W3F1-2016-0034

Subject: Response to NRC Request for Additional Information Regarding Request for Alternative to ASME OM Code Requirements for High Pressure Safety Injection (HPSI) Pump [SI-MPMP-0002AB] Testing Requirements, PRR-WF3-2016-1 Waterford Steam Electric Station, Unit 3 (Waterford 3)
Docket No. 50-382
License No. NPF-38

**Response to NRC Request for Additional Information
Regarding Request for Alternative to ASME OM Code Requirements for
High Pressure Safety Injection (HPSI) Pump [SI-MPMP-0002AB]
Testing Requirements, PRR-WF3-2016-1**

**Attachment 2
to
W3F1-2016-0034
HPSI AB Pump Curve**

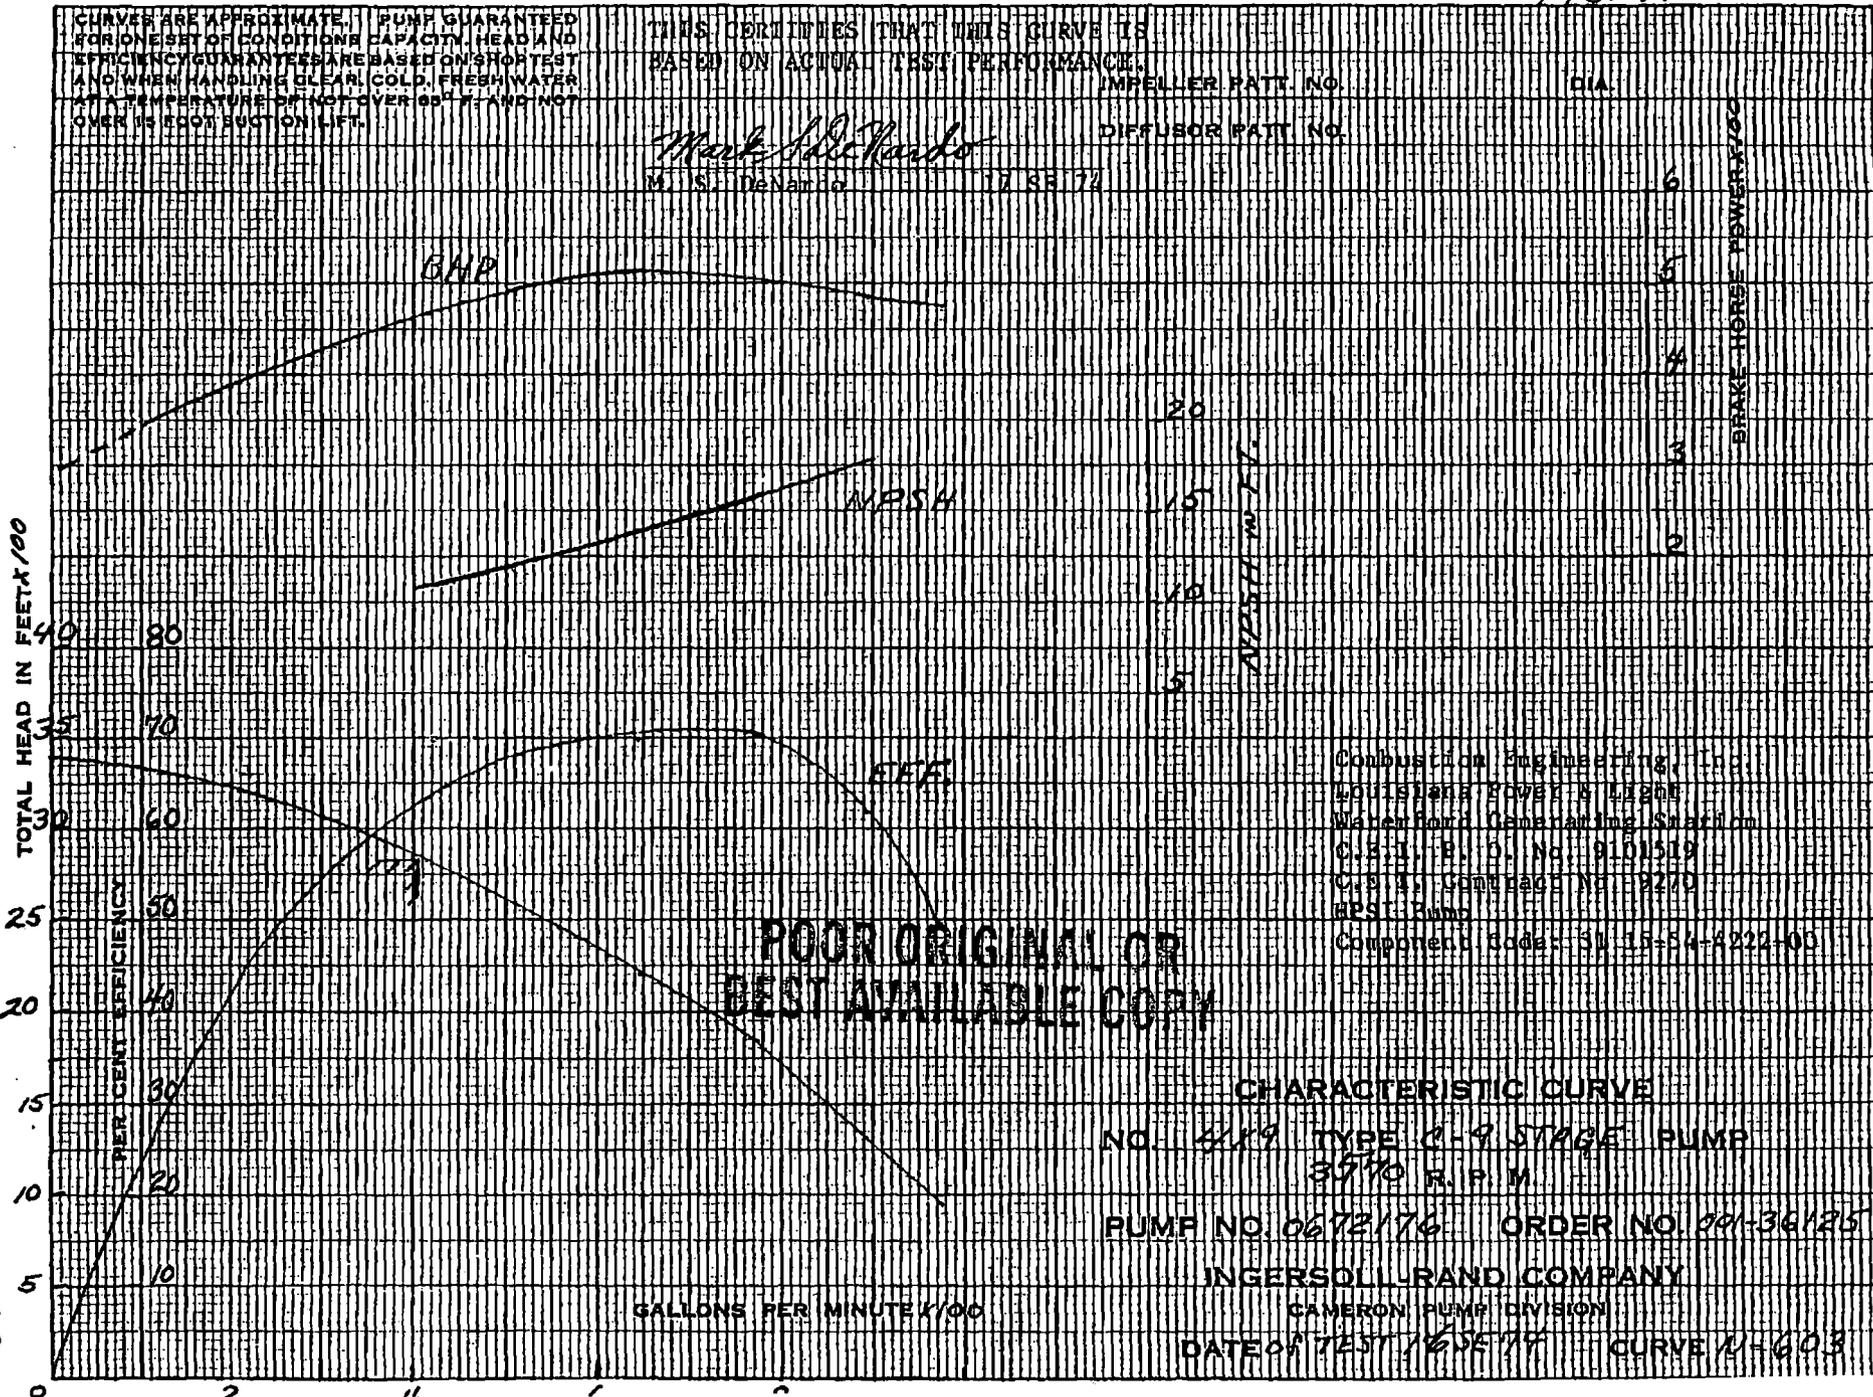
Discuss where 250 gpm and 30 gpm are located on the pump curve for HPSI Pump AB, and if they are located on a sloped portion of the curve where pump degradation can be detected. Also, provide a copy of the pump curve for HPSI Pump AB.

The HPSI Pump AB curve has a maximum flow of approximately 975 gpm. 250 gpm is located at approximately 25% of the pump curve. 250 gpm is located on a sloped portion of the HPSI Pump AB curve where pump degradation can be detected.

30 gpm is the approximate flow rate while using the minimum recirculation flow line during performance of quarterly Group B IST. This flow rate is located at approximately 3% of the pump curve. The pump curve has begun to slope at this flow rate, but not significantly.

Per Table ISTB-5100-1, a Group B test requires the differential pressure acceptable range to be from 90% to 110% of the differential pressure reference value. The reference value for the HPSI AB pump is 1451.8 psid therefore the acceptable range would be 1307 to 1596 psid. However, because the quarterly Group B test is performed using the minimum recirculation line, and TS 4.5.2(f)(1) requires a differential pressure greater than or equal to 1429 psid as indicated on minimum recirculation flow, the lower differential pressure IST acceptable limit has been truncated to 1429 psid.

This truncation brings the lower IST acceptable range limit from 90% to approximately 98.4% of the current differential pressure reference value. Incorporating the Technical Specification differential pressure into IST differential pressure acceptance criteria narrows the IST differential pressure acceptable range making degradation in pump hydraulic performance detectable at 30 gpm.

The HPSI Pump AB curve is included in Attachment 2.
